PLANNING BOARD AGENDA
JUNE 8, 2023– 7:00 P.M.

Craig Paepre, Chairman and Members of the Carmel Planning Board
60 McAlpin Ave
Mahopac, NY 10541
RE: Amended Site Plan, John Chang
716 Route 6
TM#: 76.30-1-26

Re: Site Plan
Messina Family Trust
124 Wixon Pond Road
T.M. 65.5-1-36

RE: Western Bluff Subdivision
350 West Shore Drive
Section 66.14, Block 1, Lot 20

DRAWING
EXISTING SITE PLAN LAYOUT

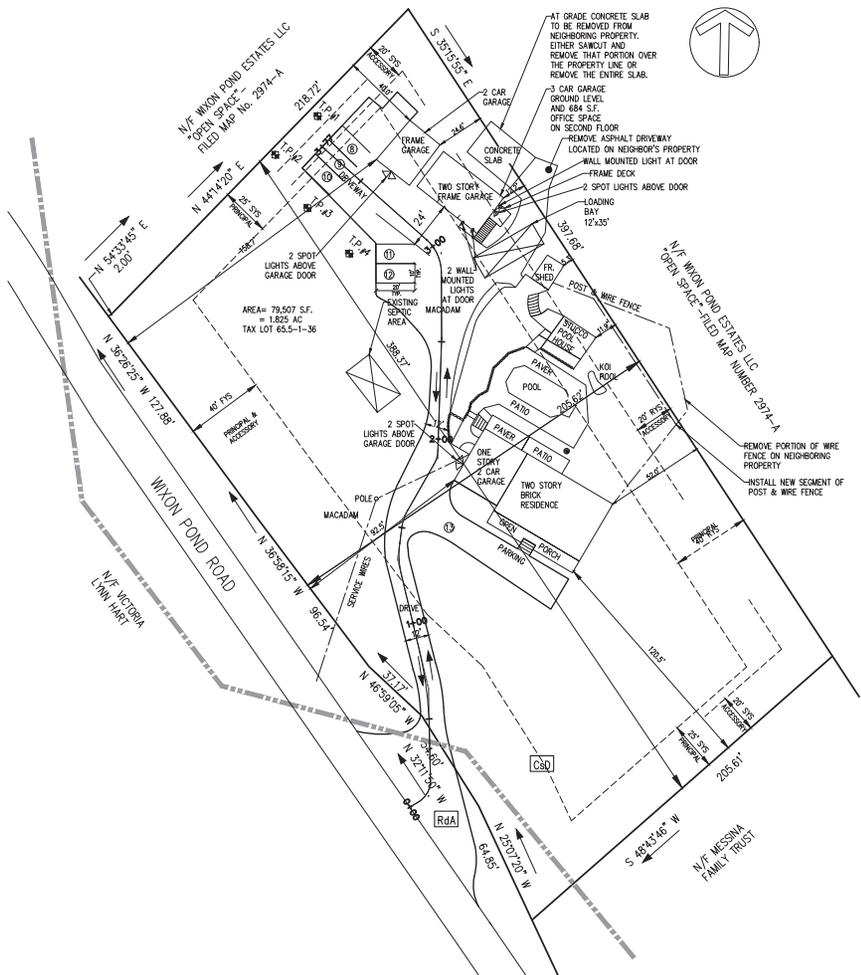
In response to comments received at the September 28, 2022 Planning Board Meeting we have proposed the following responses:

1. We have corrected Plan Sheet S-010 to state that a Use Variance is required.
2. The plan has been labelled as a Site Plan.
3. The only uses on the property are the residence and the commercial office space. The daycare/nursery school is located on the adjacent lot at 160 Wixon Pond Road (T.M. 65.5-1-37.)
4. The math in the zoning chart has been corrected. The existing lot is 79,507 s.f. in size and needs a variance of 40,493 s.f. in order to total 120,000 s.f.
5. It has been noted on the plan to either sawcut and remove that portion of the at grade concrete slab from the neighboring property or to remove the slab in its entirety.
6. Variances for the pool house, shed and garage are noted as needing rear yard accessory setbacks.
7. A separate Engineer's Report has been prepared discussing the imported fill.
8. Noted. Putnam County Health Department approval is required.

1. The at grade concrete slab that extends over the rear property line will either be removed in its entirety or sawcut and that portion over the property line removed.
The fence will be removed and reset on the applicants' property. A note has been added to the drawings.
2. A separate Engineer's Report had been prepared addressing the imported fill.
3. a. site distance calculations have been added to the plan.
b. A driveway profile has been added.

- c. The existing slope at the base of the driveway is shown on the profile and is 4.2 percent.
4. The enlarged plan of the garage/office has been revised to show locations of lighting elements.
5. Comment noted.

1. We have revised the plans to note that a Use Variance is required.
2. We have itemized the various variances required at what relief is being sought.
3. It is understood that parking requirements have been met.
4. It is understood that the off street loading area has been provided.
5. There are no proposed changes being made to this site.
